DD Topic Complaint:
27T94041 **Slipping Or Flare On 2-3 Upshift at Partial Load**

Transmissions
722.3, 722.4, 722.5

Figure 1

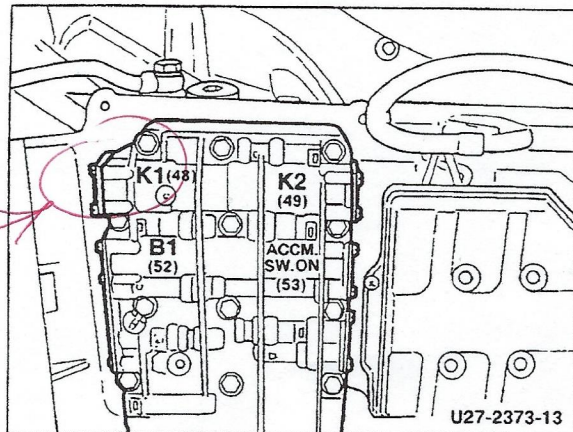
Reduction of friction coefficient in Clutch 1 inner discs.

1. Remove transmission oil pan.
 2. Unscrew end-plate of K1 accumulator (48) and remove accumulator piston with spring assembly (48, 48a, 48b).
 3. Install modified spring kit in K1 accumulator (48) of valve body accumulator housing.
- Note:**
Ensure seal rings on accumulator piston (48, Figure 2) are not damaged.
